November 30, 2020

ADDENDUM NO. 2 TO SPECIFICATION NO. 1400S
SKY CANYON SEWER PROJECT

Eastern Municipal Water District

I.D. J-25
S.A. 34
W.O. 419110
C.O.
COORD.
SHT. 12 OF 17
D-59749
C-9

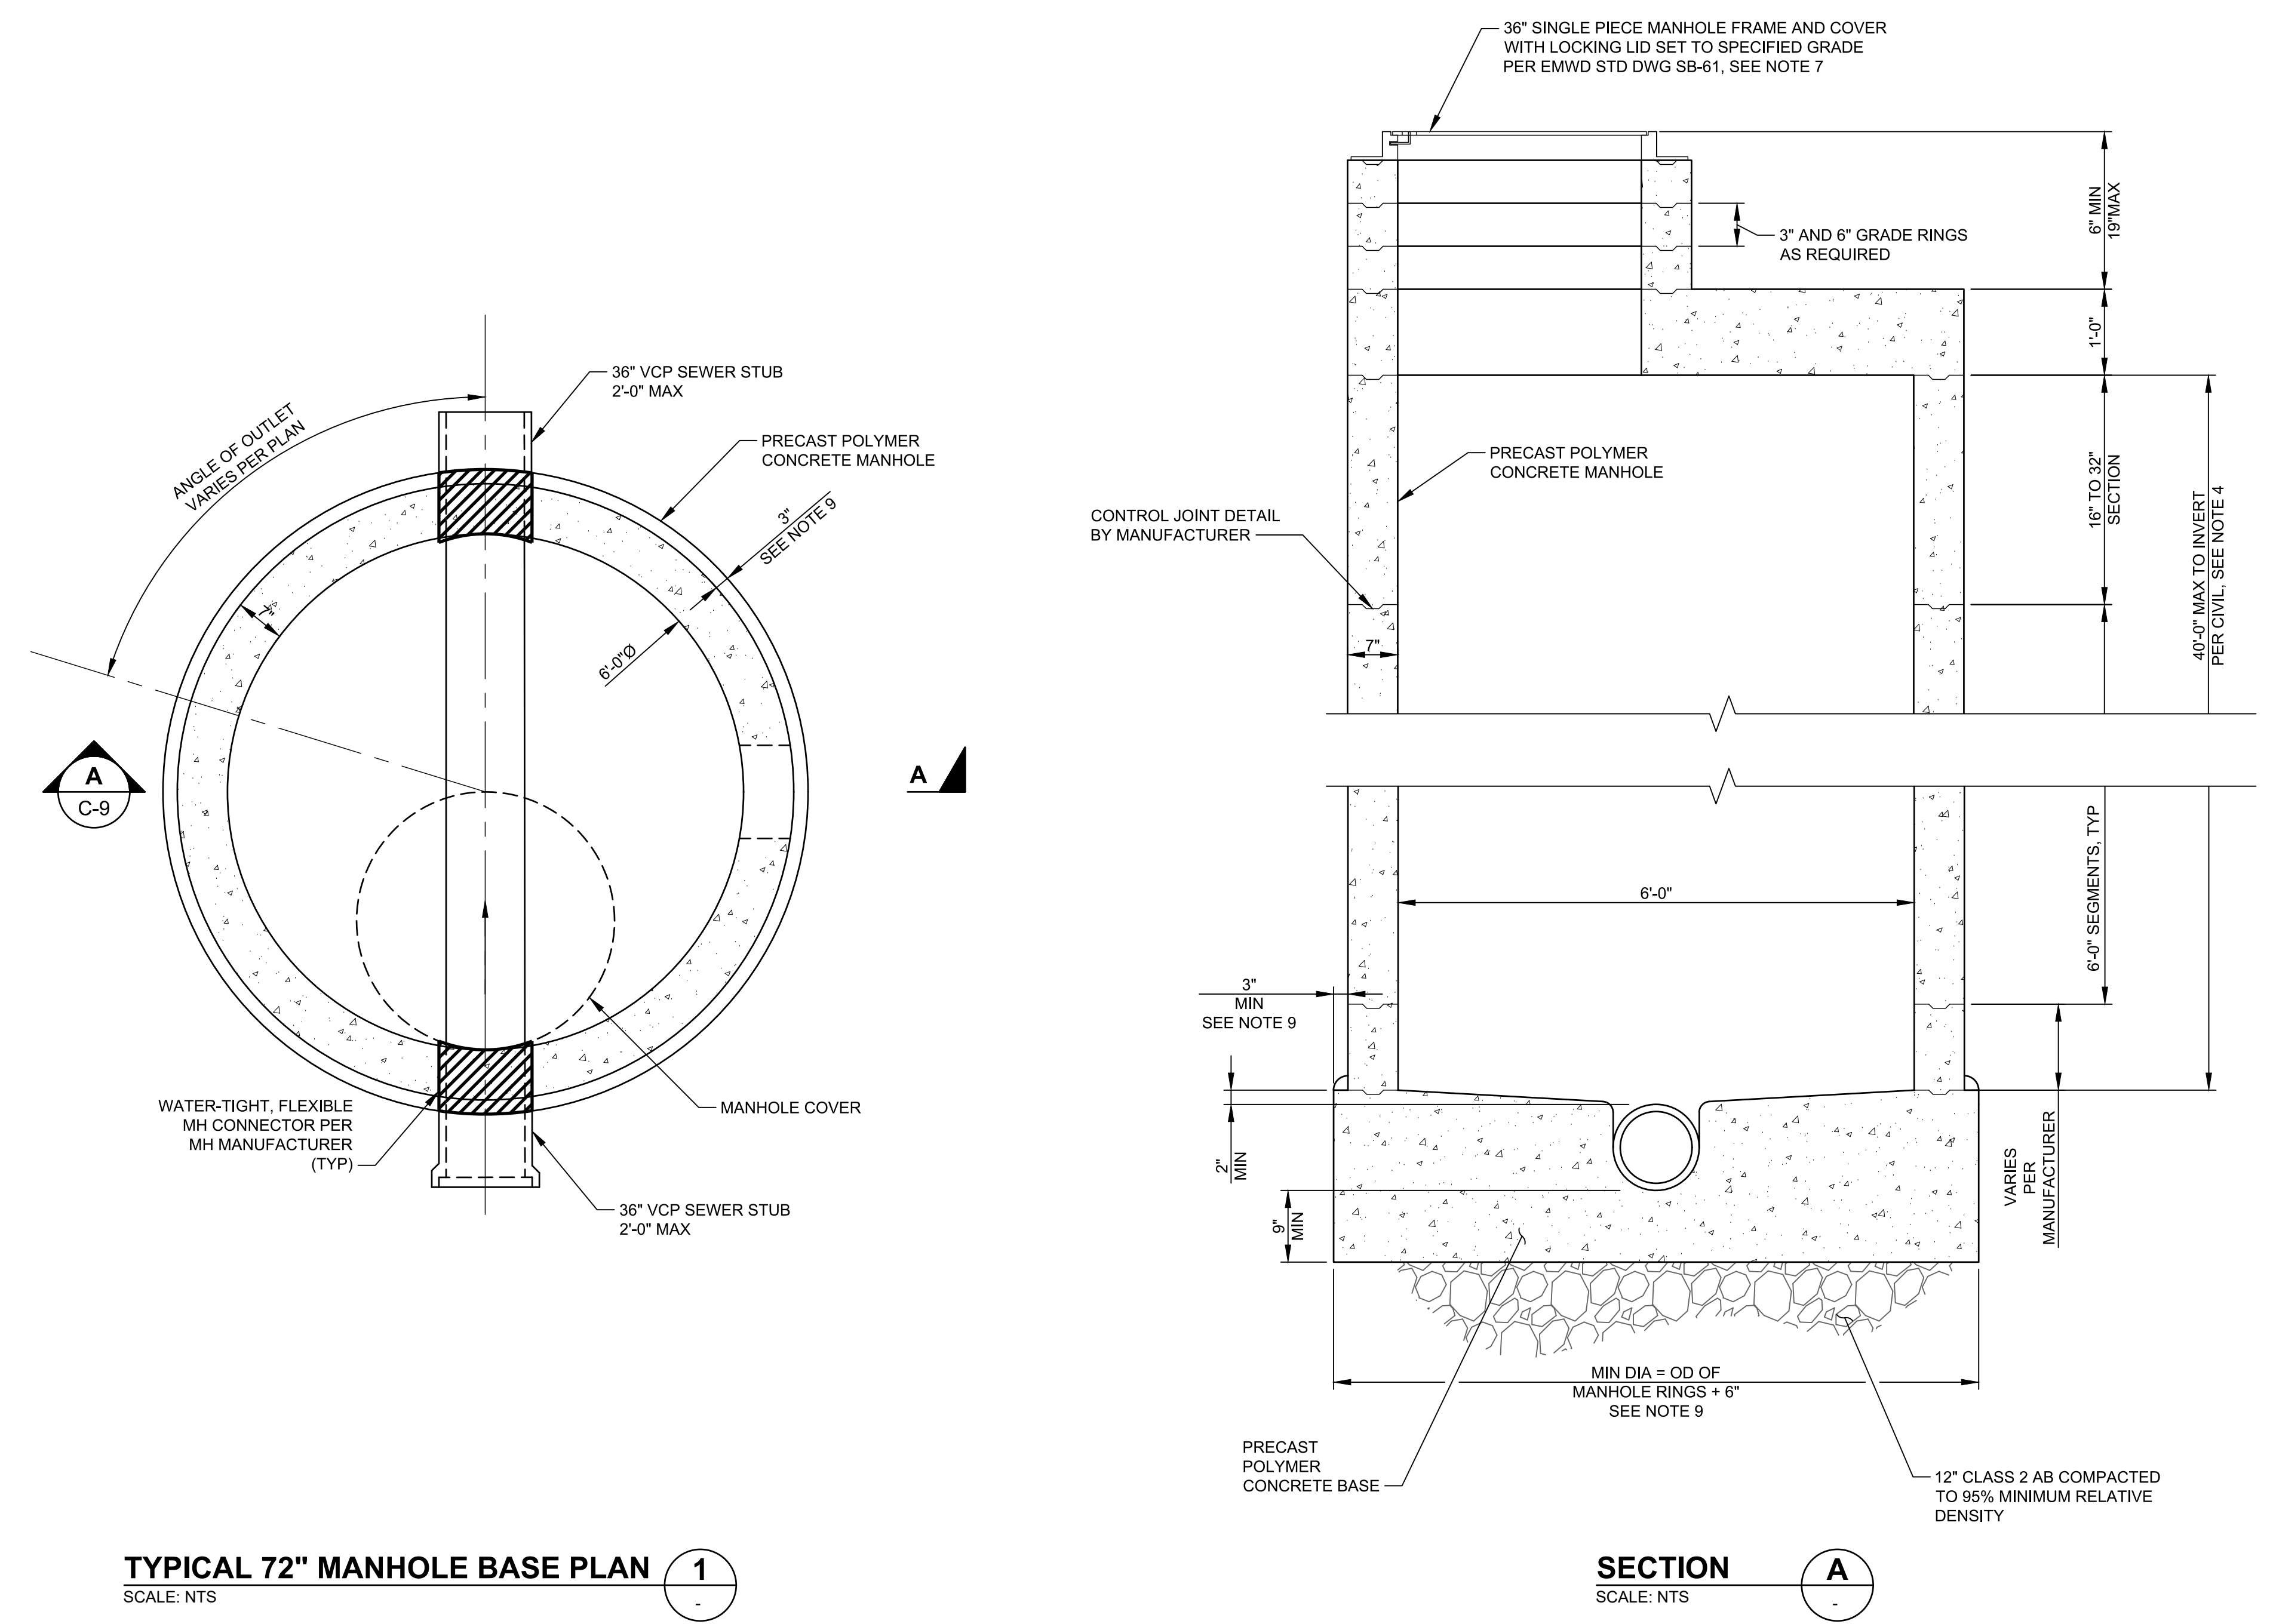
REPLACE the following drawings (revisions are shown as clouded areas):
D-59749 (Sheet C-9) Sewer Manhole Details

- Q1. Spec and polymer concrete detail updated in Addendum #1 states that in order to use a 3" wall (our standard design) the contractor will have to add at least 850 cubic feet of flowable fill (concrete) in the field to match because of buoyancy concerns. Armorock can meet the safety factor of 2.0 for this project with buoyancy slabs that are precast, thereby eliminating the need for the flowable fill. Please advise.
- A1. In lieu of minimum volume of fill concrete, Contractor may provide buoyancy resistance calculations demonstrating that provided manholes have a minimum factor of safety of 2.0 against buoyant uplift. Calculations shall be signed and sealed by a State of California registered professional engineer. Revised drawing is provided as attached to this addendum.

5. BACKFILL ADJACENT TO MANHOLE WITH CDF PER SPECIFICATIONS.
6. PRECAST POLYMER CONCRETE MANUFACTURER SHALL PROVIDE A MINIMUM VOLUME OF 850 FT³ TO PREVENT UPLIFT CAUSED BY GROUNDWATER LEVELS. WHERE CONTRACTOR SELECTS TO PROVIDE MANHOLES WITH THICKNESS LESS THAN SHOWN IN SECTION, CONTRACTOR SHALL INCREASE THE VOLUME OF CONCRETE FOR BUOYANCY RESISTANCE EQUALLY TO REDUCED VOLUME OF THE MANHOLE CONCRETE.

IN LIEU OF MINIMUM OF FILL CONCRETE, CONTRACTOR MAY PROVIDE BUOYANCY RESISTANCE CALCULATIONS DEMONSTRATING THAT PROVIDED MANHOLES HAVE A MINIMUM FACTOR OF SAFETY OF 2.0 AGAINST BUOYANT UPLIFT. CALCULATIONS SHALL BE SIGNED AND SEALED BY A CALIFORNIA PROFESSIONAL ENGINEER.
7. CONTRACTOR SHALL PROVIDE EJ 3800 SERIES COMPOSITE BASED COVERS WITH TITUS TWISTLIFT SECURITY LOCKS OR APPROVED EQUAL FOR POLYMER CONCRETE MANHOLES.
8. ALL MANHOLES SHALL BE POLYMER CONCRETE MANHOLES.
9. 3" MINIMUM WITH CONTROL JOINT FOR PRECAST CONCRETE MANHOLES AND ZERO EXTENSION FOR BASE WITHOUT CONTROL JOINTS FOR PRECAST REINFORCED POLYMER CONCRETE MANHOLES.
